REFERENCE:	Nova Bus Manuals
SECTION:	11 Fuel tank
RS N°:	—
EFFECTIVE IN PROD.:	—

SUBJECT:	60 FT vehicle metallic fuel tank
JUSTIFICATION:	Modifications to the fuel tank warranty

Figure 1 - Fuel Tank

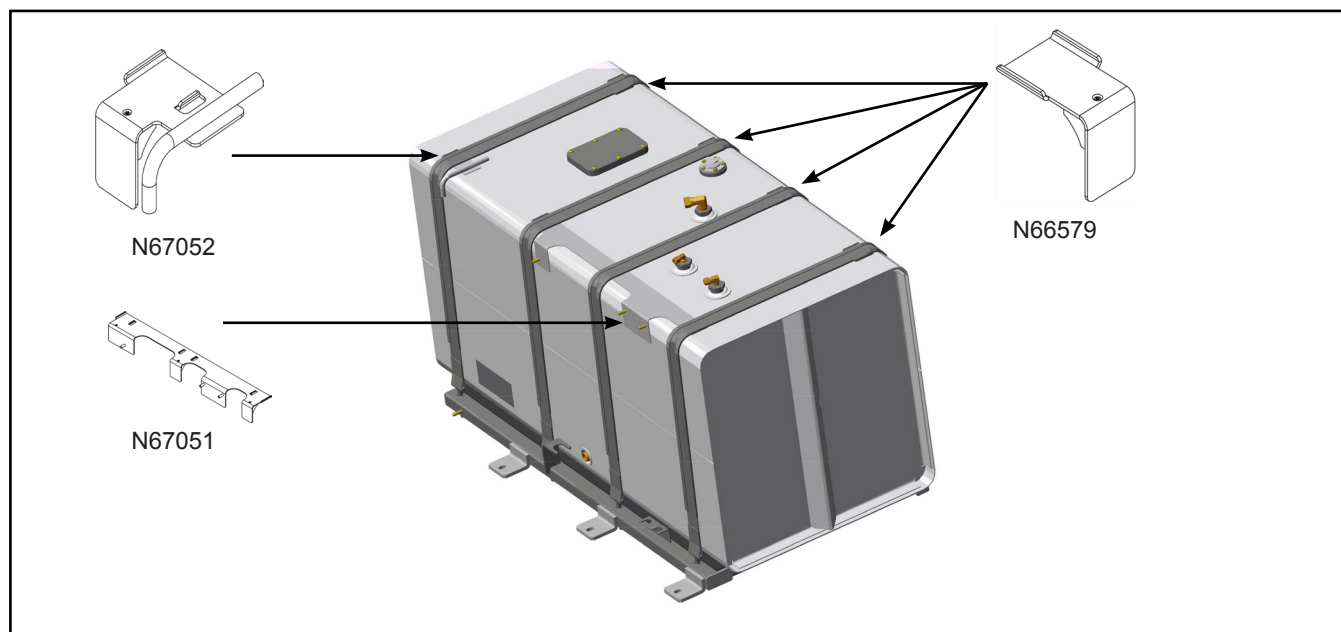
In the case of the fuel tank replacement, N67051 stud plate, the corner supports N67052 and N66579 should be installed under the fuel tank straps. See Figure 1 and the Nova Bus maintenance manual for the replacement procedure.

Figure 2 - 0724477 Connector for the Fuel Tank Return Hose

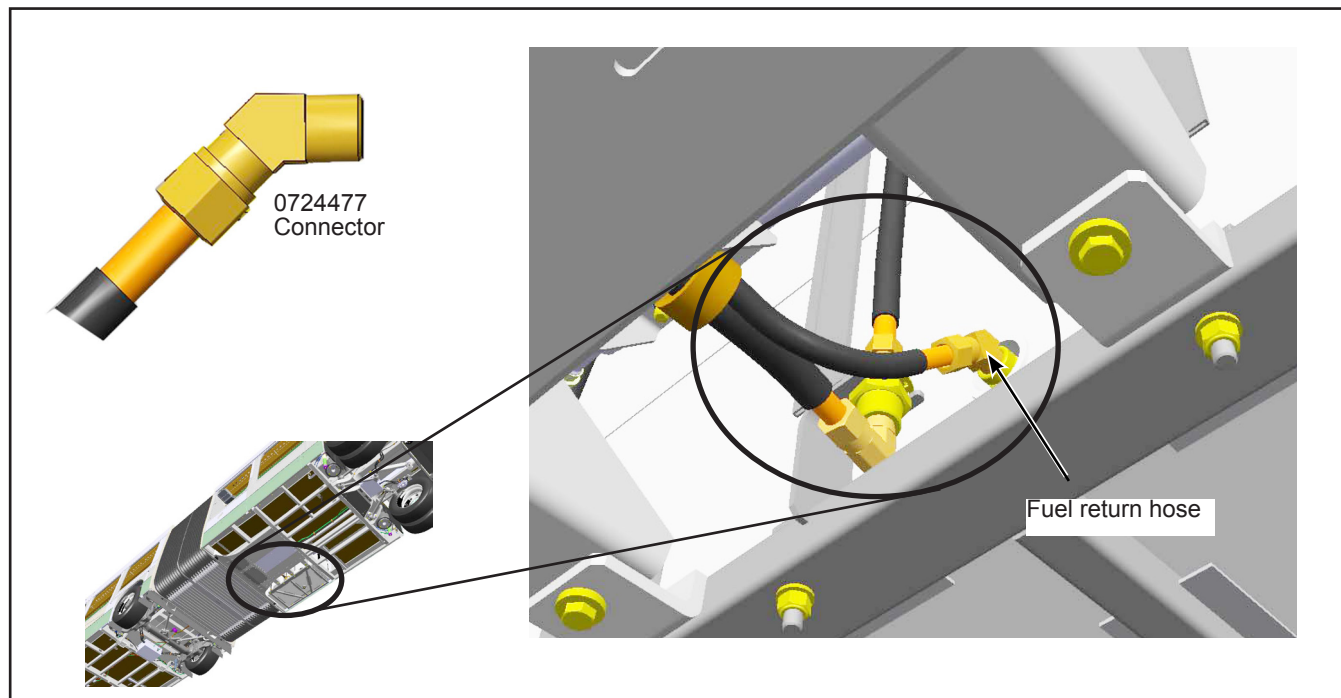
Replace the straight connector with 0724477 angle connector on the fuel tank return hose. See Figure 2.❖
